The Secretary
NSW Department of Planning, Industry and Environment

10 April 2020

I refer to the Department's below email of 1 April 2020 regarding the notice of exhibition of the Environmental Impact Statement (EIS) for State Significant Development SSD 10383 at 2 Darcy Road, Westmead (Lot 1 DP 1095407, Lot 1 DP 1211982) for Westmead Catholic Community Education Campus – 'Primary school with capacity for approximately 1,680 students, new Parish church, early learning centre, multi-storey car park and drop off zone and landscaping'. Submissions need to be made to the Department by 29 April 2020.

Padmount substation no. 7763

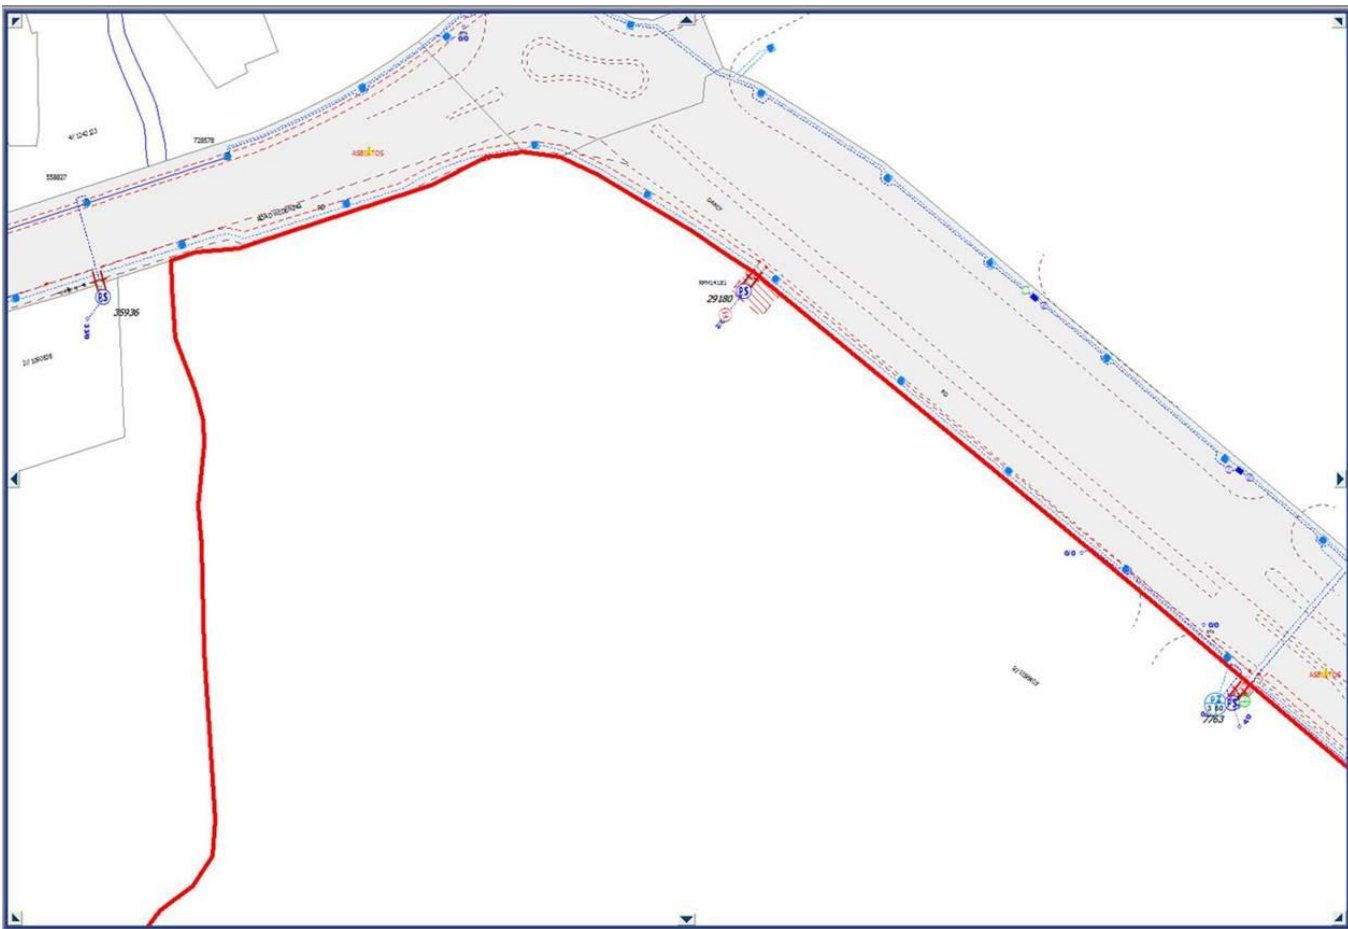
As shown in the below site plan from Endeavour Energy's G/Net master facility model (and extract from Google Maps Street View) there:

- Two easement over the site benefitting Endeavour Energy (indicated by red hatching) for padmount substations no.s 7763 and 29361 (indicated by the symbols ).
- Low voltage and 11,000 volt / 11 kilovolt (kV) high voltage underground cables to the road frontage.

The two existing padmount substations on the site:

- No. 7763 currently has 4 customer connection points servicing 7 premises.
- No. 29361 currently has 1 customer connection points servicing 2 premises.

With the exception of a customer connection point for Roads and Maritime Services from padmount substation no. 7763, both padmount substations only service the existing Campus. Neither of the two padmount substation is likely to have sufficient spare capacity to supply a significant urban development. Given the size of the proposed development an extension and/or augmentation of the existing local network is likely to be required. However the extent of the work required will not be determined until the final load assessment is completed. Endeavour Energy's preference is to alert proponents / applicants (and the Department) of the potential matters that may arise as further redevelopment of urban areas continues to occur.

In regard to padmount substation no. 7763 Endeavour Energy's Mains Design Instruction MDI 0044 'Easements and Property Tenure Rights' in addition to the easement for padmount substations now also include additional clearances / restriction for fire rating which usually extends 3 metres horizontally from the base of the substation footing, and 6 metres vertically from the same point. These were introduced on a case for case basis from 2003 before becoming standard in 2009. The easement for padmount substation no. 7763 created under RP1519 dates back to 1977 and does not include the restriction for fire rating. Whilst the fire rating restriction is not included with the easement registered on title for padmount substation no. 7763, Endeavour Energy strongly recommends that it be considered and adopted for any new development.
